IEEE 802.3 Ethernet Working Group Liaison Communication

Subject: Liaison letter to ISO/IEC/JTC1 SC25 WG3 and reply to SC25 N2352

Approval: Agreed to at IEEE 802.3 Plenary meeting, San Antonio, TX, November 6, 2014

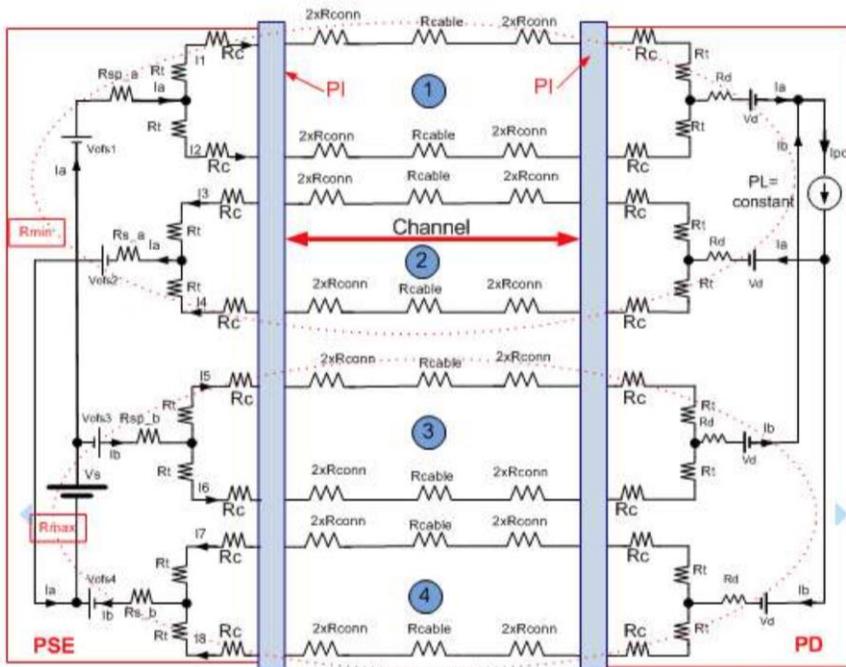
We have spent significant time looking at system unbalance, which is different than channel unbalance. We estimate that we will have 16% worst case pair-to-pair unbalance in an end-to-end system at 500mA average per conductor, which includes the 7% cabling channel figure you are specifying. This would cause 322mA of current unbalance, driving one pair to 1161mA, or 581mA per conductor, which is above the test target of 500mA. (The other pair of the same polarity will have 419mA per conductor). Is this compatible with the content of ISO/IEC 29125 Edition 2? Our calculations show that the thermal rise of the cable in this system will be less than or equivalent to a perfectly balanced system with 500mA per conductor.

Below, please find a schematic representation of our system model that shows the elements that contribute to the unbalance:

Notes for the general Model:

1. Total end to end channel connectors is 6 max.
2. The formal channel definition is marked in red arrow and is with up to 4 connectors.
3. Our work addresses also the internal application resistance of known components that are used
4. In simulations, pairs 1 and 2 components were set to minimum and pairs 3 and 4 were set to maximum values. See simulation results on previous meetings
5. $V_{ofs1/2/3}$ and 4 was added. To update the group. July 3, 2014.
